**FINDINGS AND RECOMMENDATION  
OFFICE OF PLANNING AND ZONING  
ANNE ARUNDEL COUNTY, MARYLAND**

**CASE NUMBER:** 2023-0107-V

**REQUEST**

The applicants are requesting variances to allow a dwelling (demo/rebuild) with less setbacks and buffer than required and with disturbance to slopes of 15% or greater on property located at 648 Maid Marion Hill in Annapolis.

**VARIANCE PLAN**

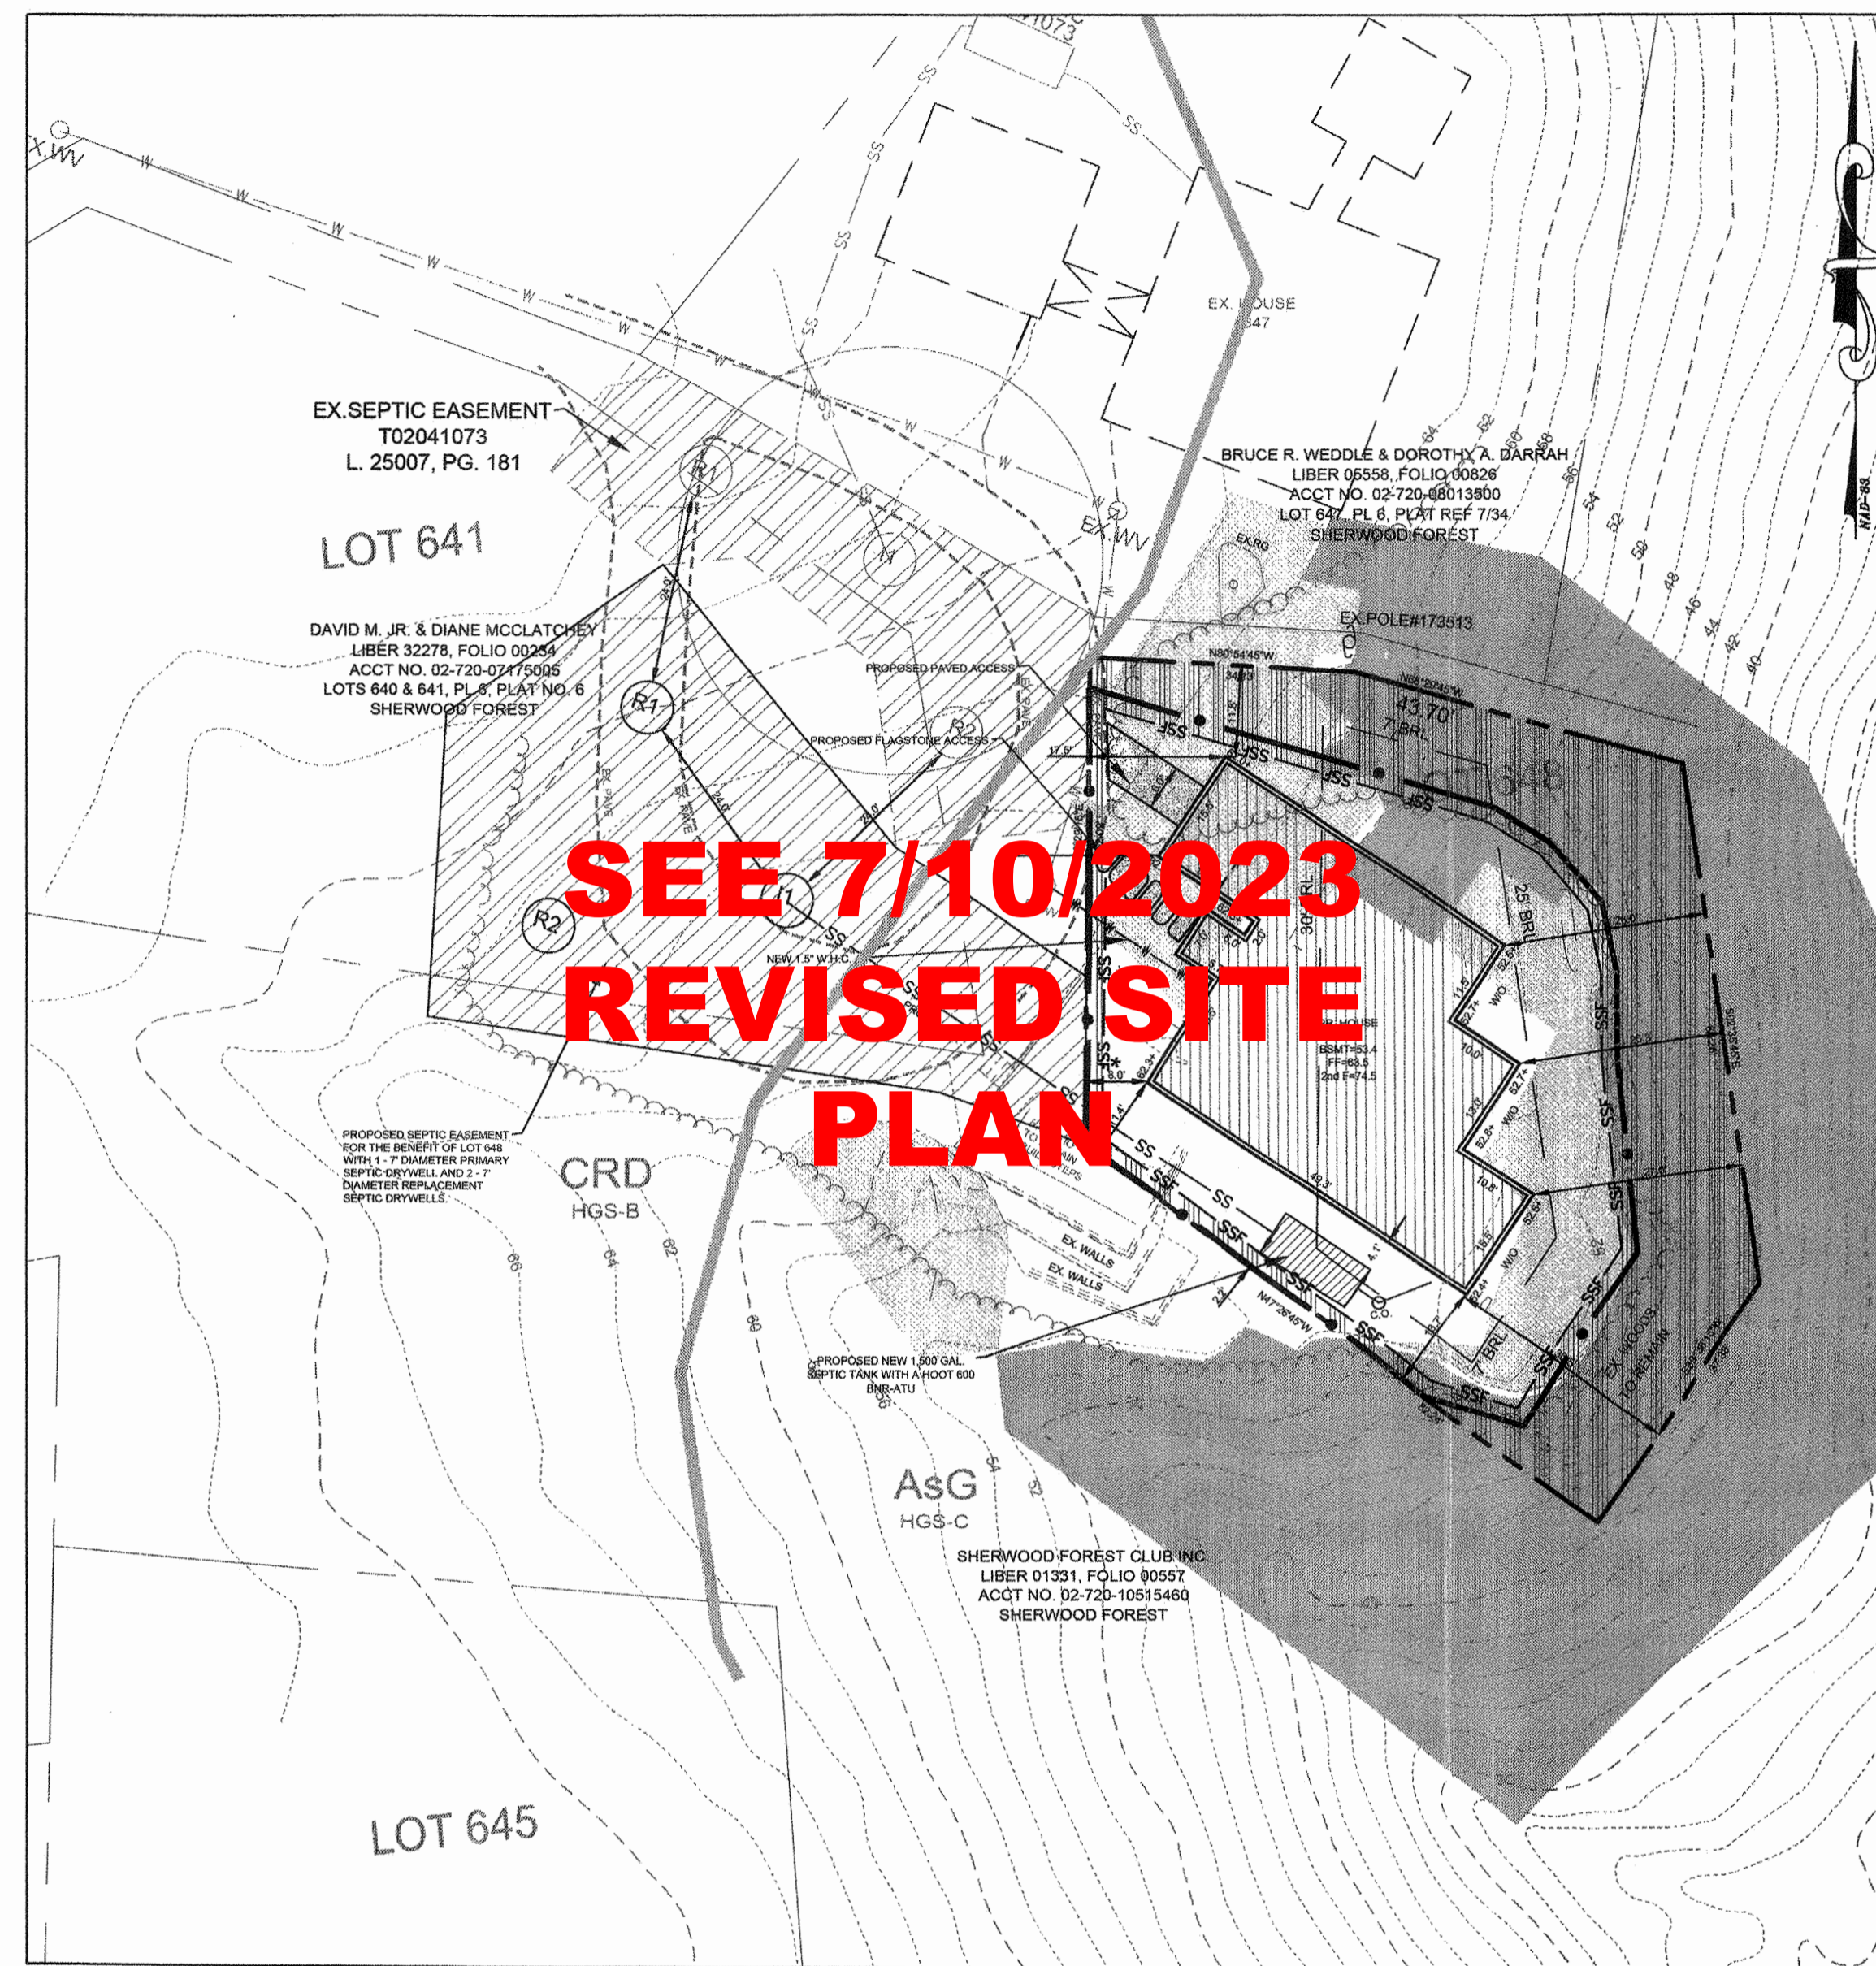
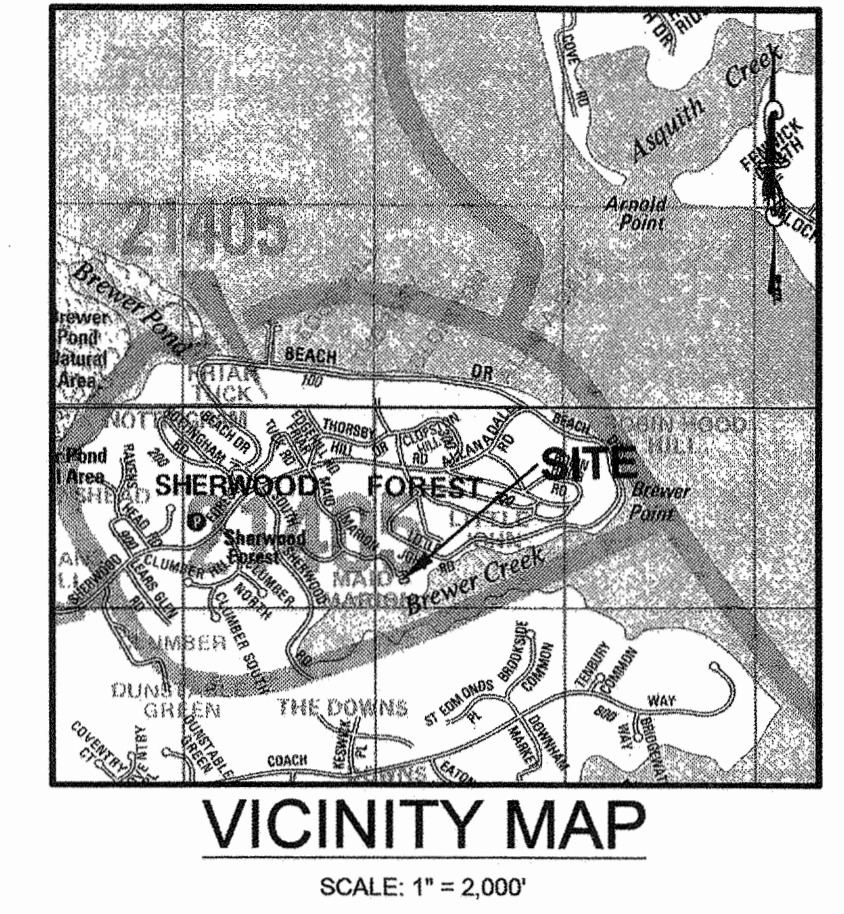
- A geotechnical report is required to demonstrate the condition of the steep slopes under existing conditions, identify the need for slope stabilization, and needs for retaining structures.
- The designer needs to provide information showing how the site's drainage and risk from erosion on the steep slope are being addressed.
- Due to the increased impervious coverage, permeable pavement should be considered in lieu of the proposed impervious cover for the sidewalks and driveway.

The **Critical Area Team** commented that the proposed home sits at the top of a 55% slope. The applicant has indicated that the reason for the setback request is to allow the home to be placed as far from the slope as possible when in fact, the home is at the top of the slope and the rear setback. The proposed home has 5 bedrooms, 4 full baths, 2 half baths; a garage; a sitting room, family room and a living room; an Office and a Library and an Art Room. While it is true that a large portion of the lot is encumbered by steep slopes, that should not be the basis for the variance but an indication that the lot will only support a home of a certain size. This proposal does not meet the requirements for variance approval. Mitigation and SWM must be addressed with the permit application. A modification will be required for the disturbance of the required slope buffer. Approval of a variance does not guarantee the approval of the modification. The modification decision will be subject to the requirements of 17-2-108.

While encroaching into the front setback may be unavoidable, there appears to be an opportunity to design the proposed dwelling to avoid the steep slope disturbance to the north. The granting of the variance as proposed would confer on the applicants special privileges that would be denied by COMAR, Title 27.

Determination – Since this proposal is for a demo/rebuilt versus a “new single-family home” and the LOD is less than 5000 SF, the site is exempt from the SWM regulations and will be required to provide SWM planting per Code Section 17-8-405. This office supports this variance request on the condition that the comments above are addressed with the grading or building permit approval.

**PRE-FILE VARIANCE PLAN**  
**648 MAID MARION HILL**  
SHERWOOD FOREST, PLAT 6  
TAX MAP 39, GRID 19, PARCEL 298, LOT 648  
TAX ID#: 02-720-02352000  
SHEET NO: 1 OF 1

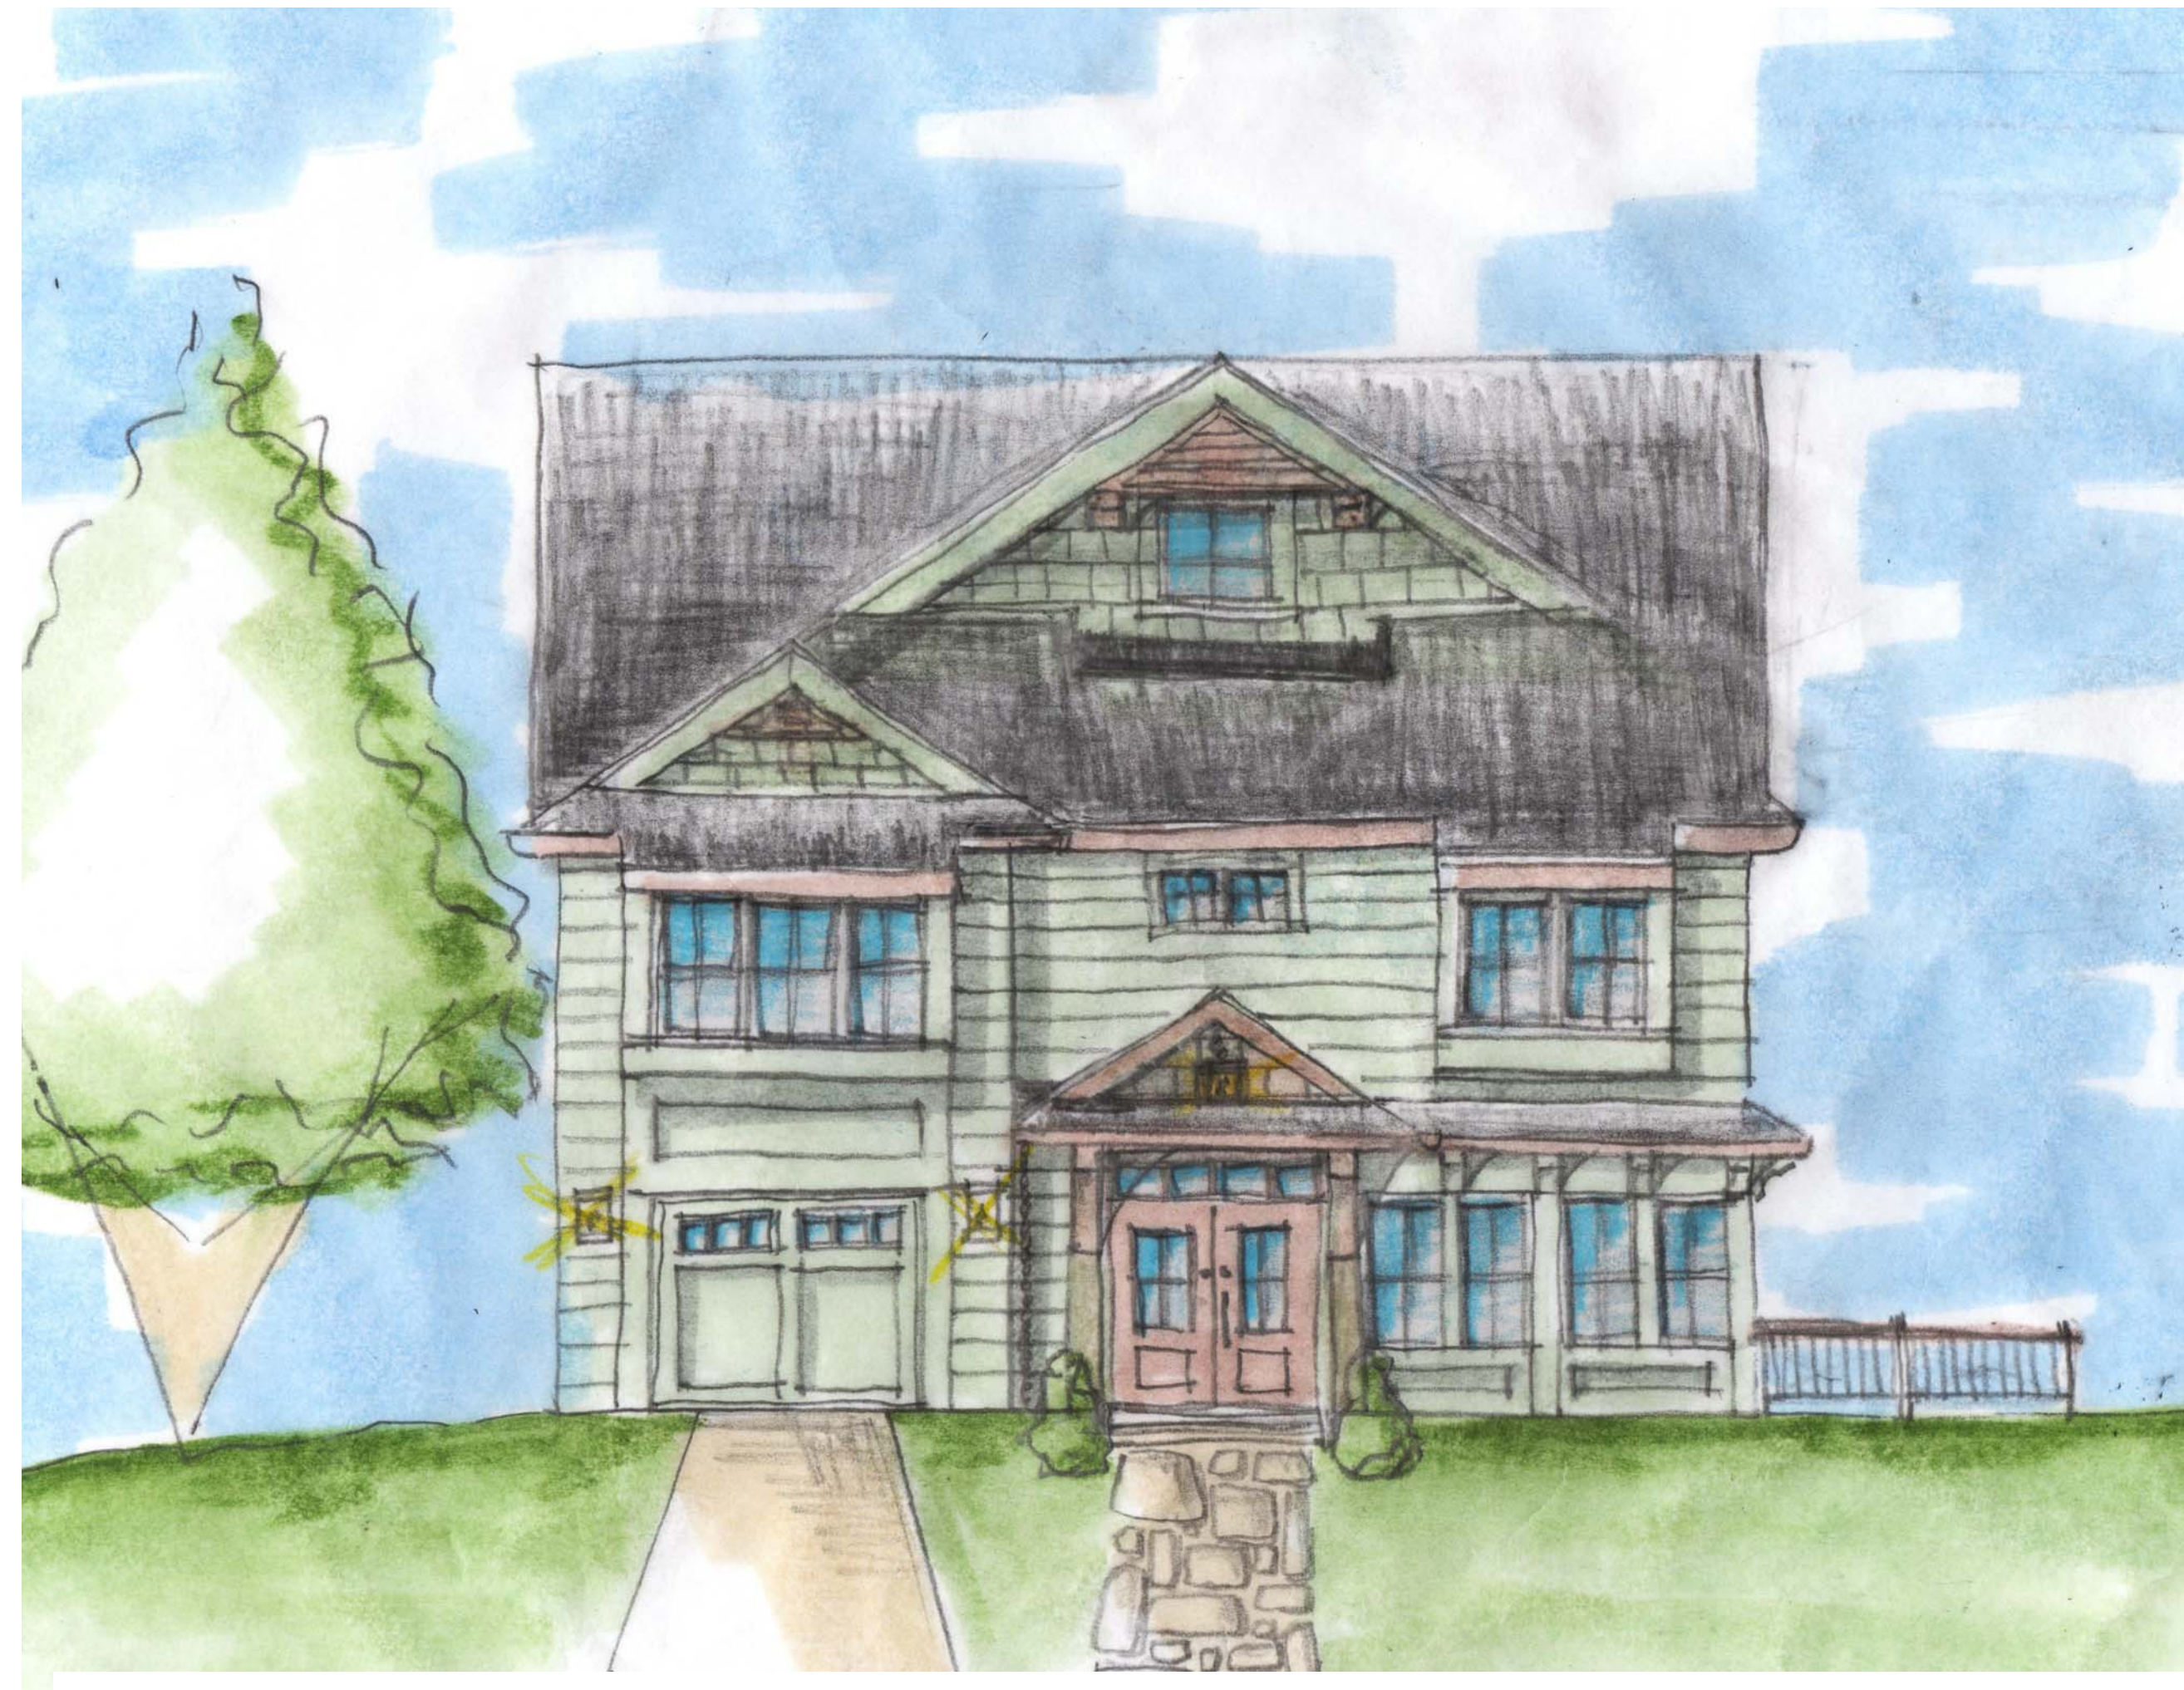
1. Per CA Team comments the variance is NOT to the 25' buffer and expanded buffer to slopes but is simply a variance to steep slopes.
2. The dwelling is 9.5 feet from the front lot line which makes the variance a 21 foot variance request.
3. Add the height of the proposed dwelling onto the site plan in the middle of the proposed structure.
4. LOD disturbance to slopes has been noted on the site plan. Include the permanent disturbance to slopes as well.
5. Provide lot coverage calculations on the site plan.
6. The R2 District allows a maximum coverage by structures of 30%. Provide the Coverage by Structure calculations. If the Coverage by Structure is greater than 30% then a variance is required.

The designer needs to provide information that shows how the drainage for the site and risk from erosion on the steep slope is being addressed. Further, an explanation of why the impervious area is being increased from 1,899 to 2,216, efforts to minimize this increase, and how the increased runoff will be mitigated on the steep slopes.
